<b>Office Action Summary</b>	<b>Application No.</b> 10/537,096	<b>Applicant(s)</b> LANSDOWN, KEVIN SYDNEY	
	<b>Examiner</b> Bradley H. Duckworth	<b>Art Unit</b> 3632

## **DETAILED ACTION**

FIG. 1

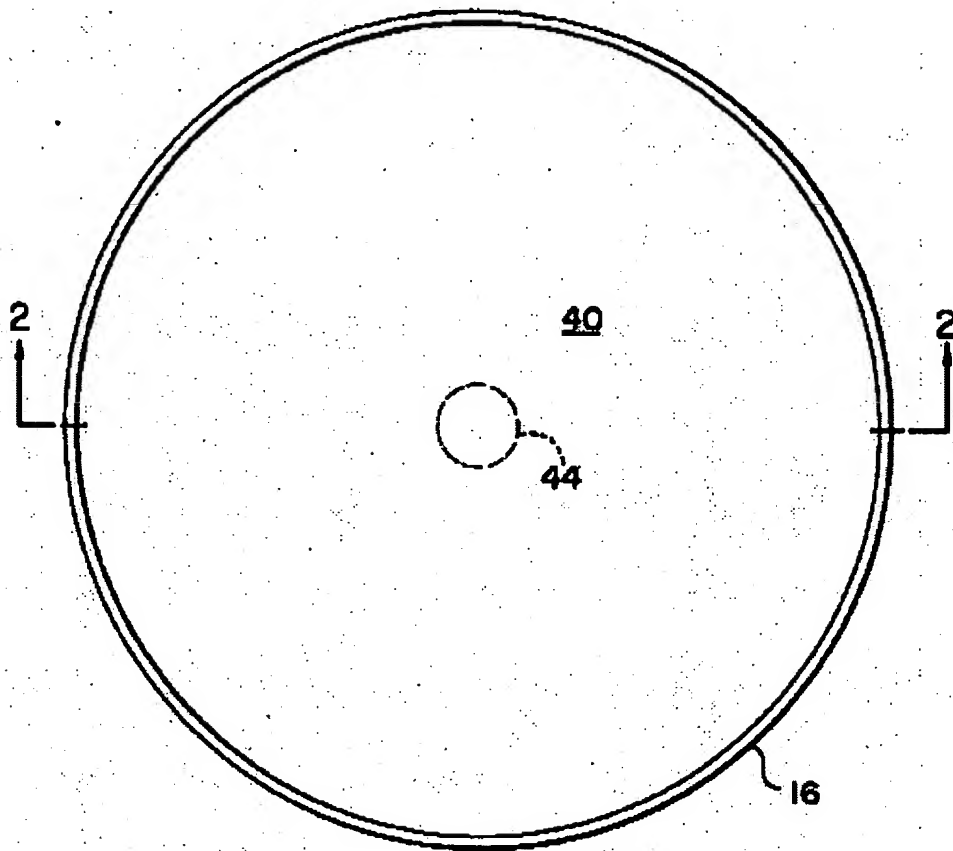
Claims 22-29,32,33,and 36-41 are rejected under 35 U.S.C. 102(b) as being anticipated by Blevins et al. (US005479867). Referring to figures 1 and 2, and further in view of the aforementioned interpretations in the objections and rejections sections, Blevins teaches a rotary table with a platform(40) that has a substantially planar upper surface and a base(10) with the platform supported on the base by a rotation means further comprising bearing means which are radially spaced from the center of the platform and base where the bearing means comprise ball bearings, further comprising constraining means comprising a ridges(50) that are provided on opposite sides of the platform that define recesses defined by the ridges(42) that is capable of receiving and restraining the wheels of a trash container, further with the ridges converging toward each other from the front end of the platform to the rear end, with any section being the front as the ridges are in the form of a circle which converges with itself at any point on

the outer edge of the platform, further with a ridge at the rear of the platform that could act as a stop to restrain a waste container, again with any section being named the rear, whereby the ridges define a platform area that would be complementary to a cross section of a waste container with the same shape. The platform further being rotatable from a first position to a second position approximately 180 degrees from the first position. Further with any portion being an entry/exit for an article received on the platform where the entry/exit is bounded at least on opposite sides by said ridges.
